## SERVICE BULLETIN

### REVISION 1 to SERVICE BULLETIN SB-T-03-RDR-1FB-001

#### NC-105B NAV Concentrator

**Subassembly Mod 4 to Master Processor Module  
P/N 3606423-0501**

FIGURE 1  
VIEWED FROM SOLDER SIDE

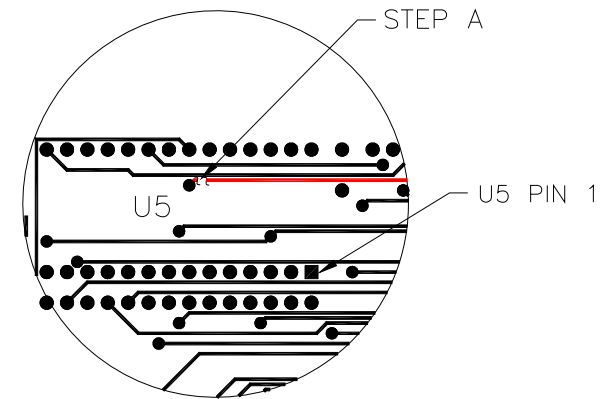
ON THE SOLDER SIDE OF THE BOARD, IMPLEMENT THE CUT LISTED IN THE CUT TABLE (TABLE I) AS SHOWN IN FIGURE 1. COVER ALL CUTS WITH FIND NO 6. USE THE LISTED CONTINUITY POINTS AS VERIFICATION THAT CONTINUITY HAS BEEN BROKEN.

| CUT TABLE I  |       |                   |
|--------------|-------|-------------------|
| VIA UNDER U5 | U5-22 | U2-5 TO U5-22     |
| U11-9        | VIA   | U11-9 TO TP19     |

FIGURE 2  
VIEWED FROM COMPONENT SIDE

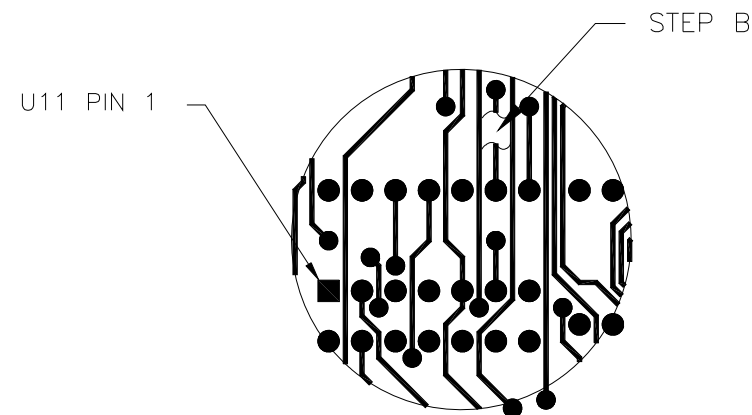
ON THE COMPONENT SIDE OF THE BOARD, IMPLEMENT THE CUT LISTED IN THE CUT TABLE (TABLE I) AS SHOWN IN FIGURE 2. COVER ALL CUTS WITH FIND NO 6. USE THE LISTED CONTINUITY POINTS AS VERIFICATION THAT CONTINUITY HAS BEEN BROKEN.

FIGURE 3  
VIEWED FROM SOLDER SIDE

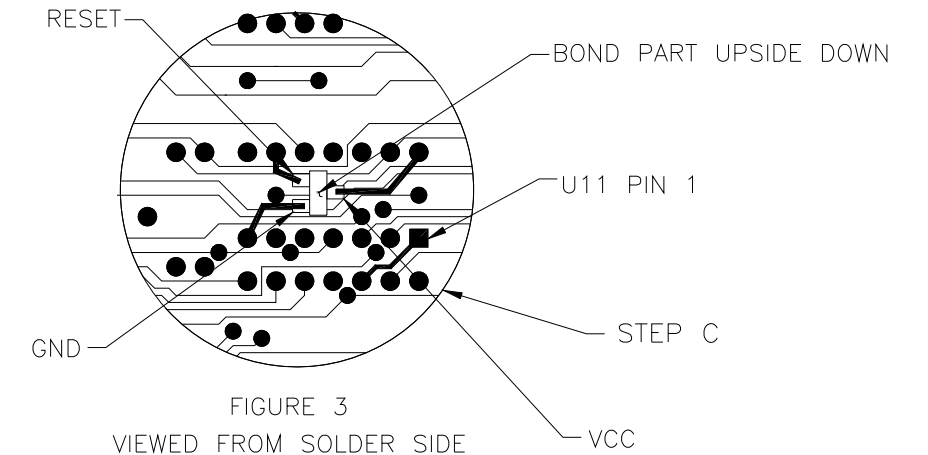
ON THE SOLDER SIDE OF THE BOARD INSTALL COMPONENT (F/N 70) & JUMPERS IAW THE JUMPER TABLE (TABLE II) USING FIND NO 7 AS SHOWN IN FIGURE 3. TACK BOND THE JUMPERS TO THE BOARD AS NEEDED USING FIND NO 8. VERIFY THE JUMPERS BY TESTING BOARD CONTINUITY AS INDICATED IN TABLE III.

| JUMPER TABLE II |        |                   |
|-----------------|--------|-------------------|
| U5-22           | U9-22  | U5-22 TO U2-3     |
| U24-GND         | U11-7  |                   |
| U24-VCC         | U11-14 |                   |
| U24-RESET       | U11-9  |                   |
